515 Chatham Street - Development Permit with Variances **Application No. 00034 (Downtown)**

An application to allow for construction of a five-storey, mixed-use building containing ground-floor commercial uses and residential units above.

515 Chatham Street
Development Permit With Variance #00034

IRONWORKS
OLD TOWN VICTORIA
515 Chatham Street
Victoria, BC

CHATHAM STREET ELEVATION - CURRENT PROPOSAL

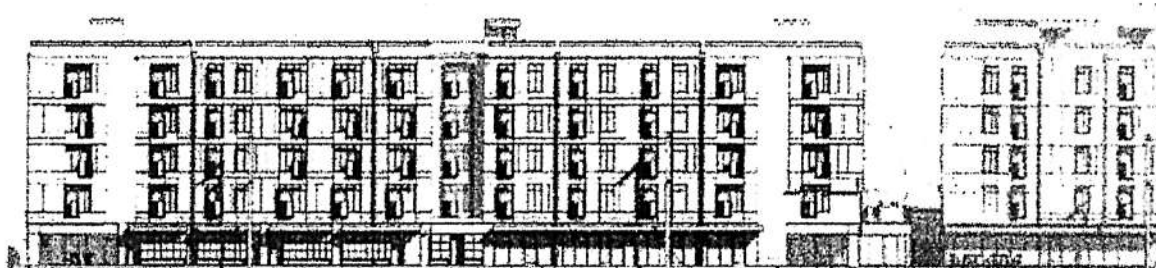
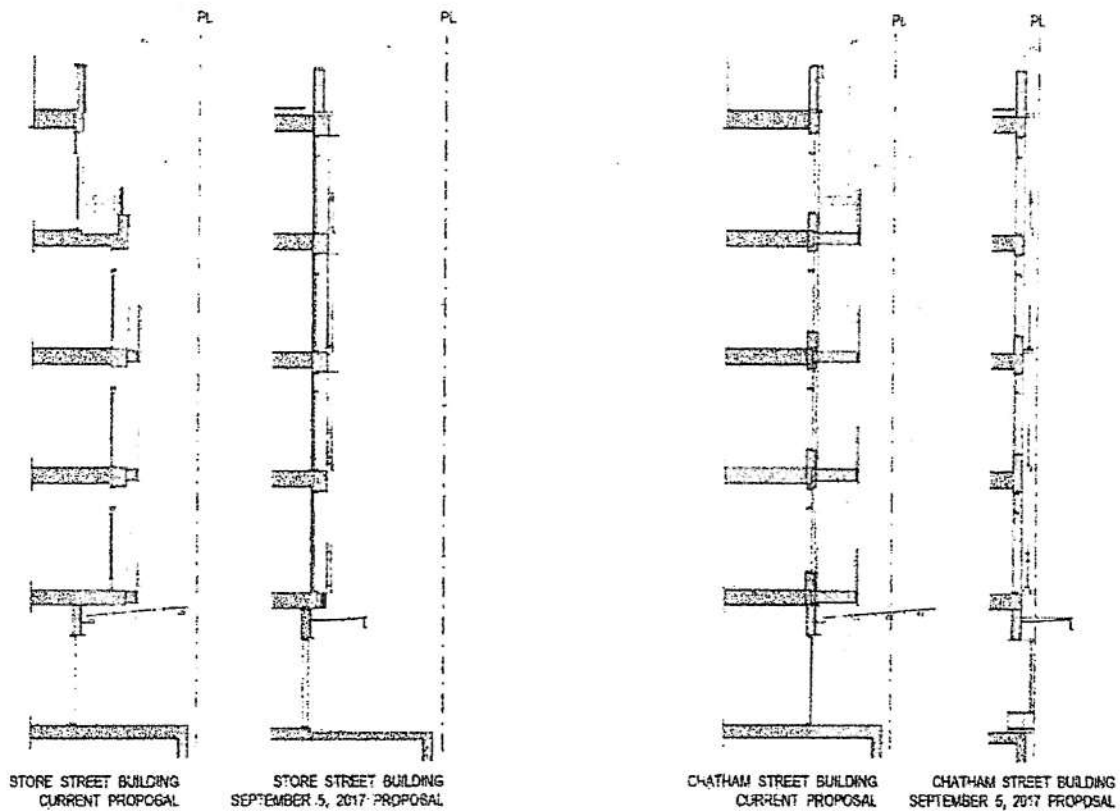
RECOMMENDATION: That the perceived scale and massing of the building be reduced to better fit with the fine grain and small lot character of the Old Town district.

- Increase in size and scale of articulation in the project façade. The main plane of the building has been pulled further back from the property line (1.595m at Chatham Street and 0.945m at Store Street) and substantial bays added to effectively break up the perceived mass. The articulation is further reinforced by the introduction of full walk out balconies.

CHATHAM STREET LEVEL PLAN - CURRENT PROPOSAL

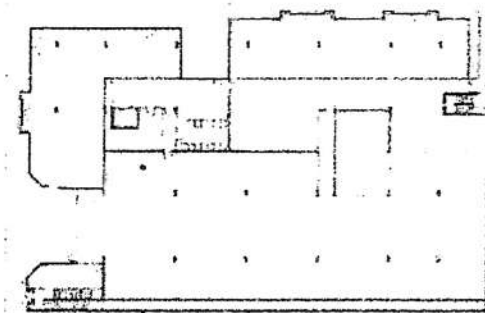
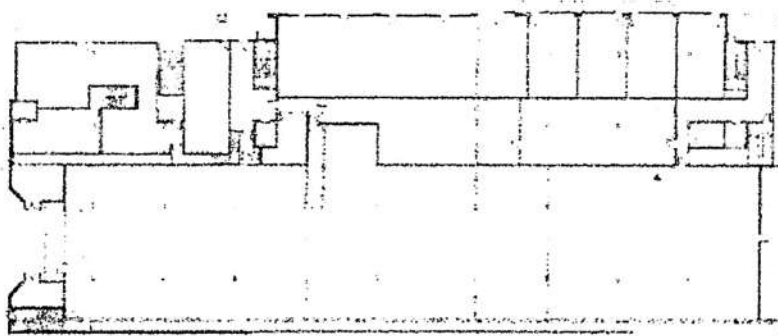
RECOMMENDATION: That additional opportunities be created for “lingering” in the public realm along Store and Chatham Streets

- Increased building articulation at street level. A sequence of covered recesses and eddies have been developed along the building edge at street level that encourage a range of commercial and pedestrian activities on the site.
- Increased shelter in public realm. The commercial level canopy has been substantially increased in depth and provides meaningful weather protection along both the Store Street and Chatham Street elevations.
